From: John Bolecek [johnbolecek@gmail.com]
Sent: Tuesday, September 06, 2016 8:35 AM
To: Markham, Lory P. - PDR
Cc: Helmboldt, Jakob C. - DPW
Subject: CPC 25th St Grovery Store Comment

From: Nicholas Smith [telso314@gmail.com] on behalf of Nicholas Smith [nicholas@nicholassmith.ca]
Sent: Monday, September 05, 2016 9:55 PM
To: Markham, Lory P. - PDR
Subject: Comments on UDC 2016-211
Attachments: Plans 2.png; Plans 3.png; Plans.png; Iddkpnbcckfklfk.png

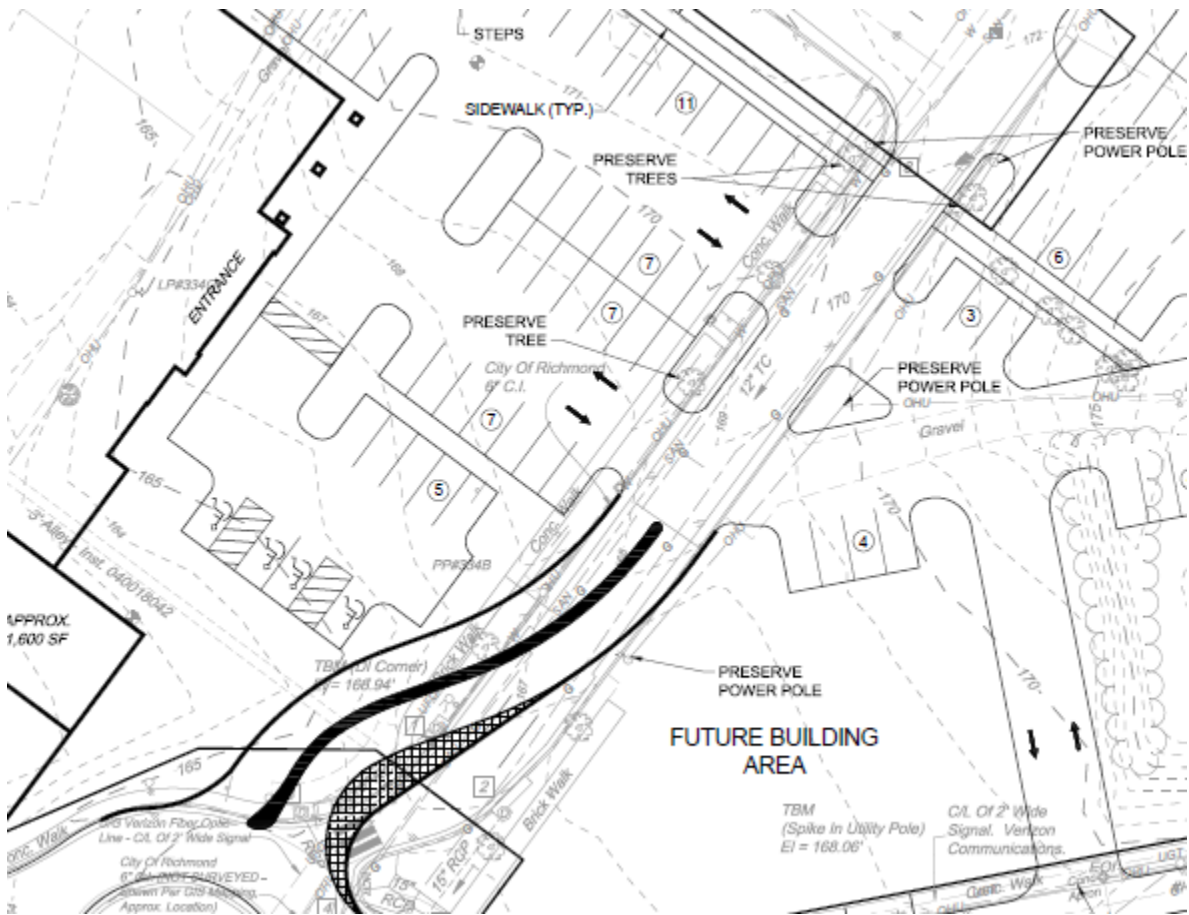
First, there doesn't seem to be a crosswalk along the northern edge of the roundabout, where the realigned 25th Street will be; if this is the case, it would be a downgrade for pedestrians compared to the current layout. Given that and the expected vast increase in traffic expected, this is not acceptable. There should be a designated, high-visibility place to cross with ADA ramps and a refuge island.

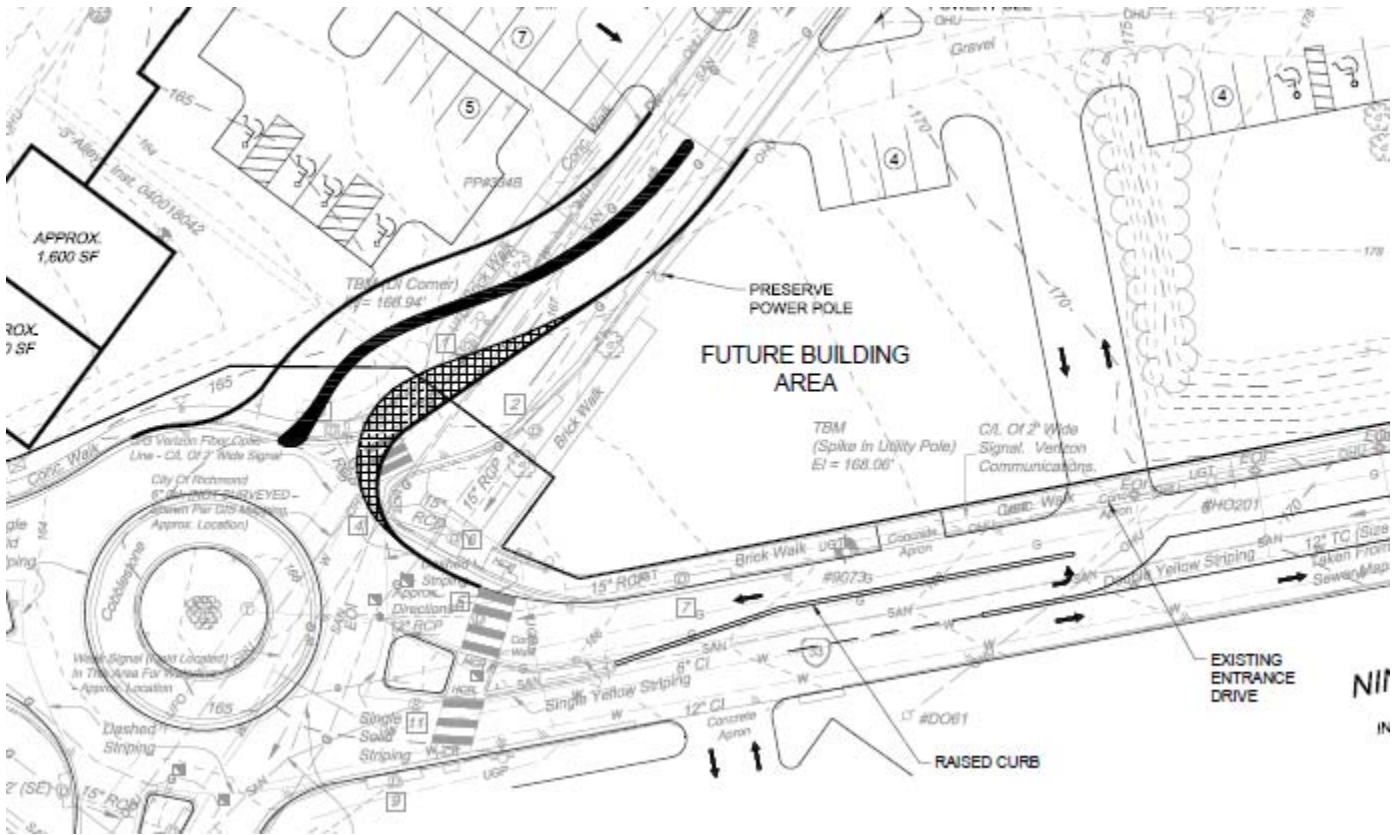
Nor is there a crosswalk, or even a logical place to cross 25th Street mid-block, between the two parking lots. This means that if someone parks in a parking lot on one side of the street and wants to go to a building on the other side there is nowhere to cross except the most dangerous place -- where the cars are trying to enter and exit the parking lot. This should include an ADA ramp and high-visibility crosswalk somewhere mid-block on 25th Street between T Street and the roundabout, and if this can't fit safely then one of the (many) parking lot entrances should be removed.
